Department of Infrastructure and Regional Development

DECISION UNDER THE AIRPORTS (PROTECTION OF AIRSPACE) REGULATIONS 1996:

Proposed Activity: Building Construction: Property Development

Location: 6-16 Atchison Street, St Leonards NSW

NORTH ELEVATION

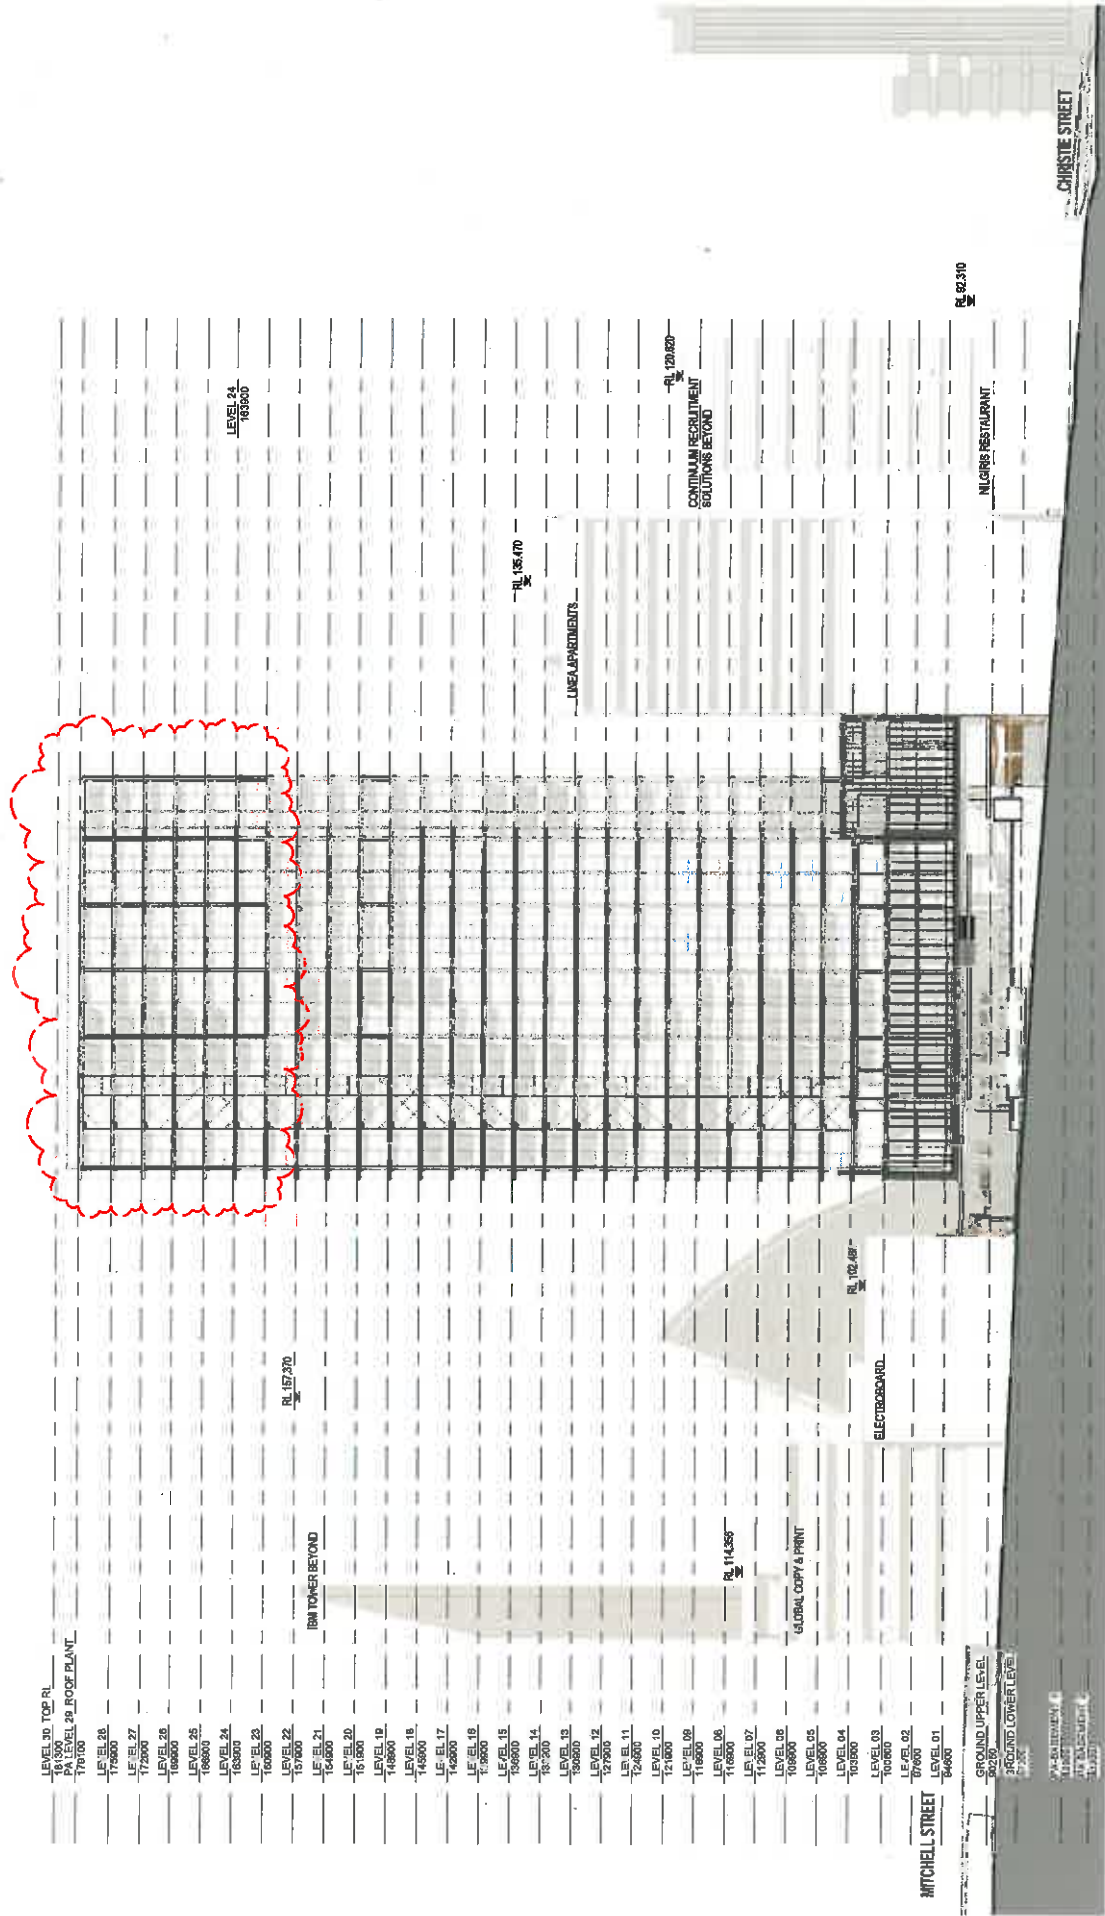
The Outer Horizontal Surface of the OLS above this site is at a height of **156 metres** Australian Height Datum (AHD) and hence prescribed airspace above the site commences at **156 metres**. At a maximum height of **181.3 metres AHD**, the building will penetrate the OLS by **25.3 metres**.

Attachments A1-A2 show the location and height of the building which will intrude into prescribed airspace at the site.

1. The building must **not exceed** a maximum height of **181.3 metres AHD**, inclusive of all lift over-runs, vents, chimneys, aerials, antennas, lightning rods, exhaust flues etc.

2. The building **must** be obstacle lit with medium intensity steady red obstacle lighting in accordance with the Manual of Standards for Part 139 (Part 139 MOS) of the Civil Aviation Safety Regulations 1998, section 9.4.

3. The obstacle lights are to be arranged so that they indicate the points or edges of the object to ensure the object can be observed in a 360° radius.
